Comment on Eversource position statement, X-178 complete rebuild.

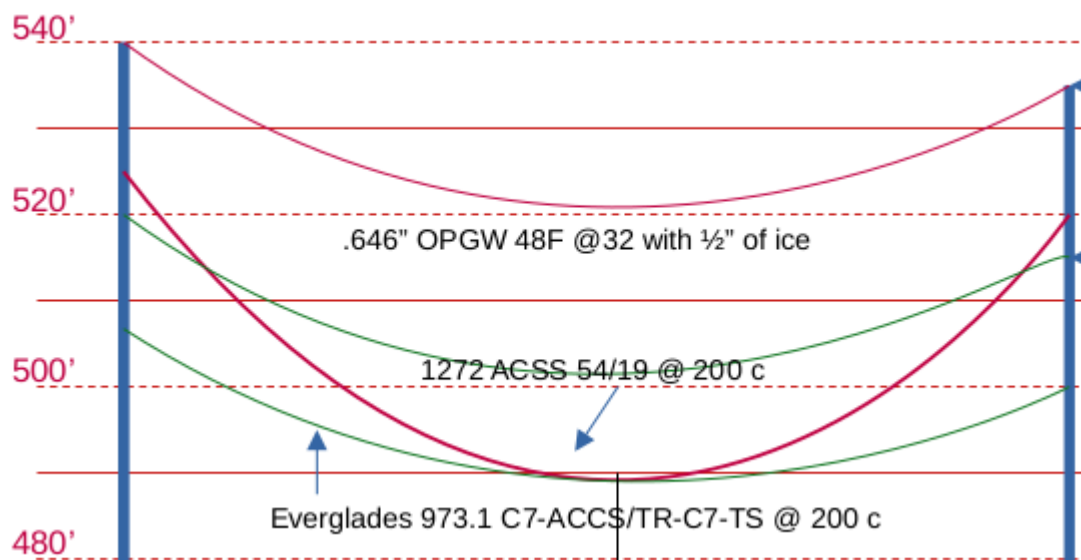
“Height increases are driven by the need to comply with current National Electrical Safety Code clearance requirements. Accordingly, the incremental changes resulting from the proposed Project benefit the public health and safety.”

Height increases are driven by Eversource’s plan to install OPGW, larger high-sag conductor, and Eversource’s guaranteed rate of return of 11+% on its investment. The clearances are also greater than required by Code as is clear in the profile drawings. So the structures are taller than is required for Code compliance. Eversource has not shown that it cannot comply with Bethlehem’s height restrictions by using ACCC-type conductor, of a lower amperage than the 1272 if necessary and by not installing the easement-violating OPGW. (Below: 739’ span:)

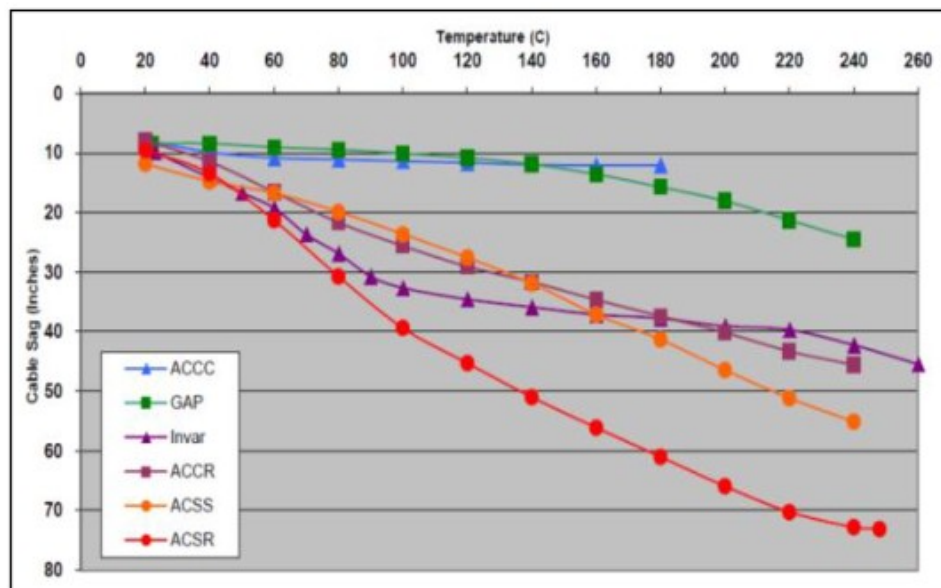
Where are the profiles showing that Eversource could not, using advanced ACCC type conductor, lower structure heights by 20' on average, which would allow Eversource to use the existing structures after cutting off the decaying pole tops inspection notes mention frequently?

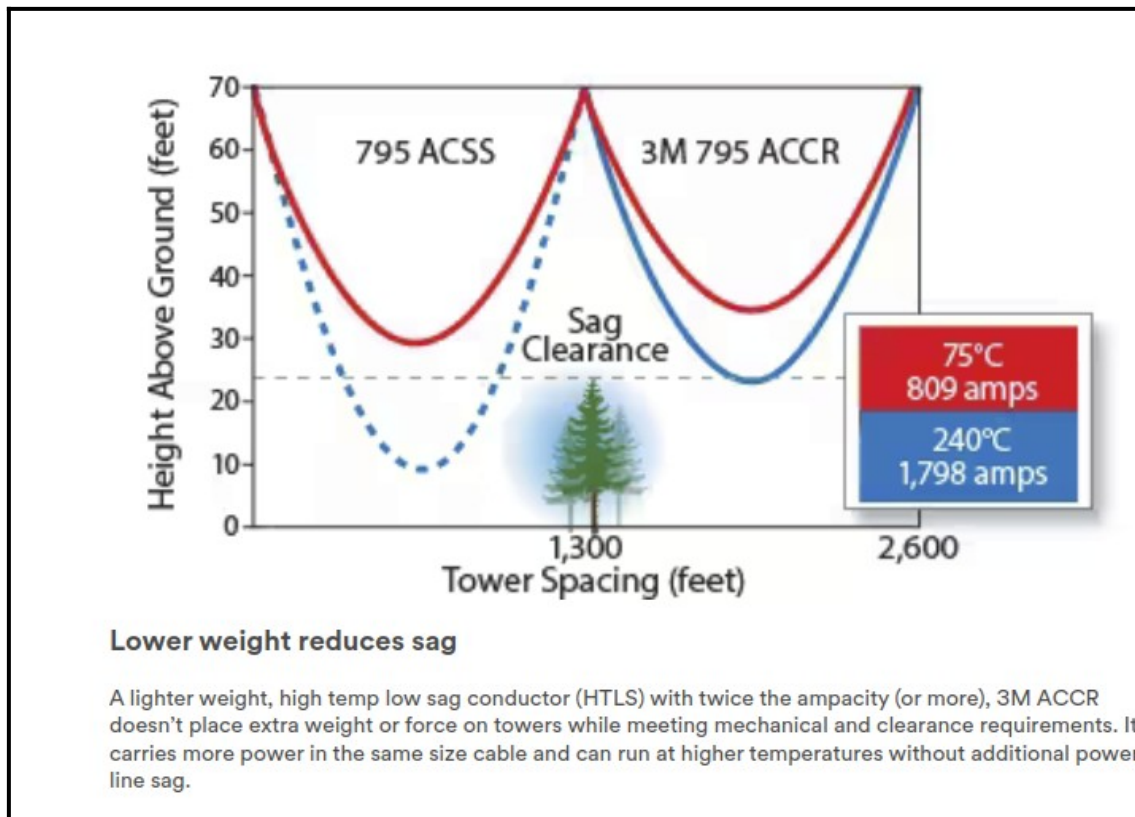
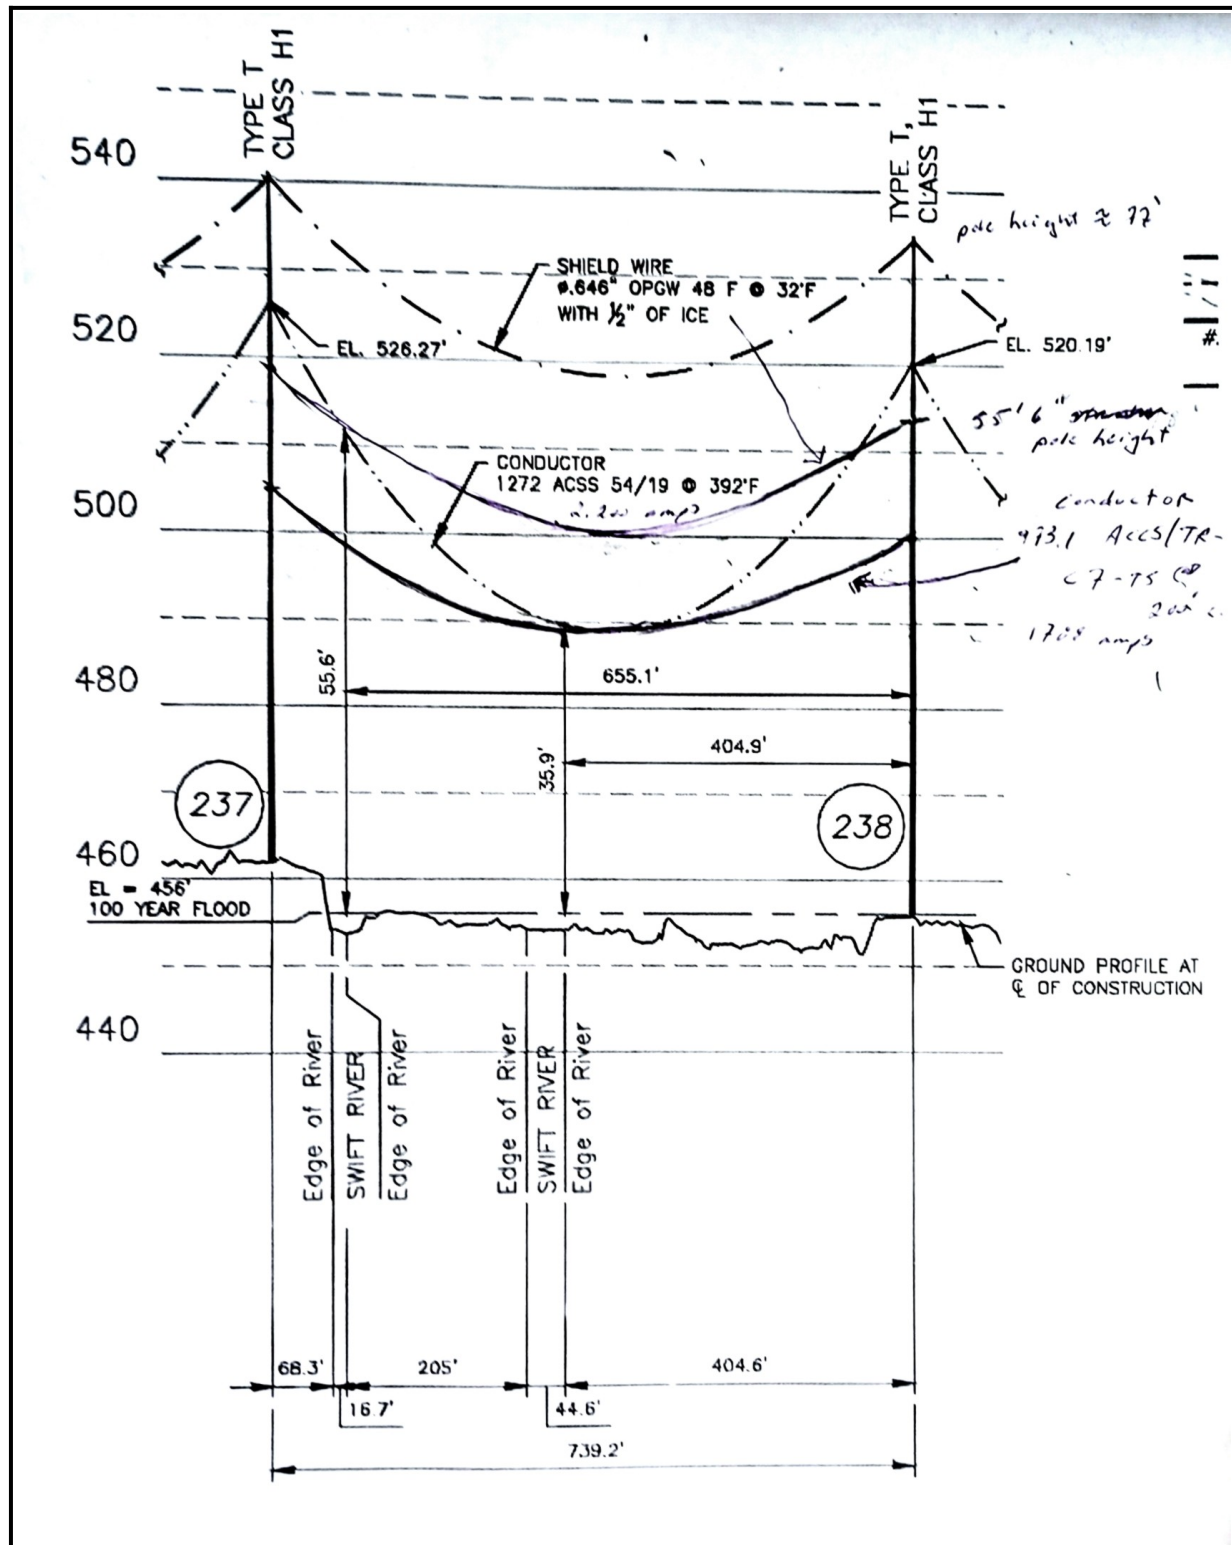
Lowering the 55' 6" structure with the ACCS/TR conductor 13' to reduce the clearance to 22.9' would allow a structure height of 42' 6". Using static wire or SkyWrap fiber on the conductors would lower the structure height by another 5', to 37' 6".

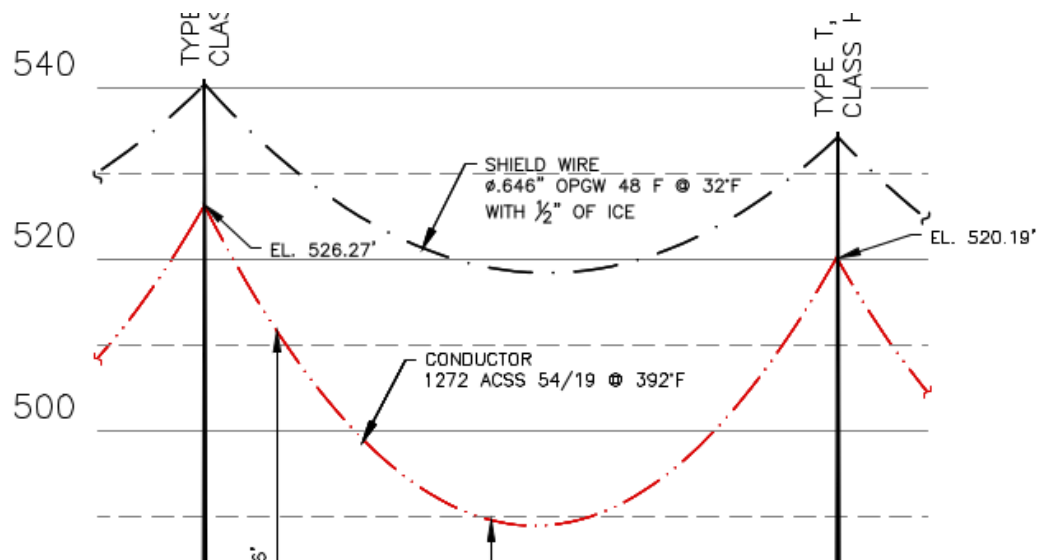
Below, Eversource profile from the X-178 showing 15' clearance for the OPGW:

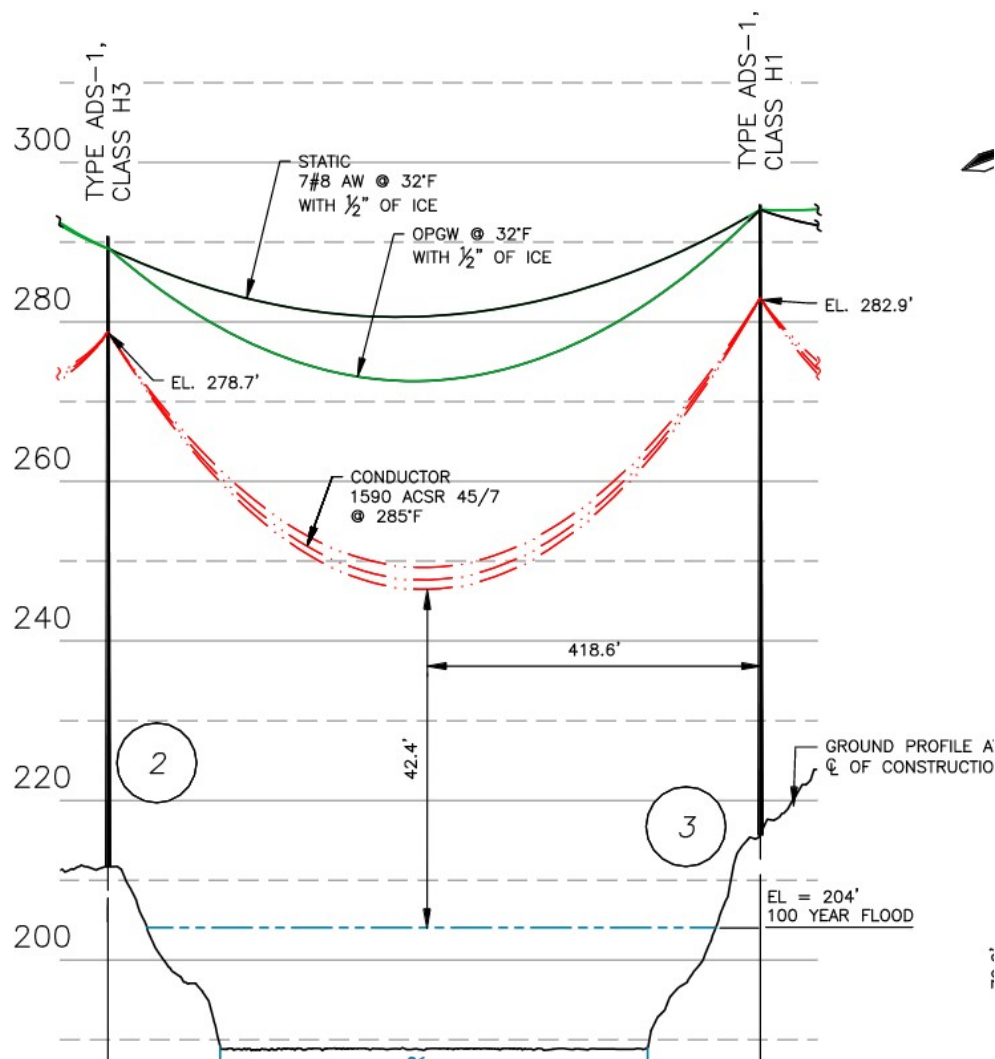
Below, another Eversource profile showing lower sag of regular ground wire and 11'-12' clearance with another OPGW. Eversource has not offered any change in the OPGW to reduce structure heights.

Eversource claims a deep concern about structure integrity yet did not find that safety or reliability warranted placing braces on the structure on the right or on the several ones north of it on which the cross-bars and insulators were also replaced (without TV coverage of Eversource performing “Emergency Repairs.”)
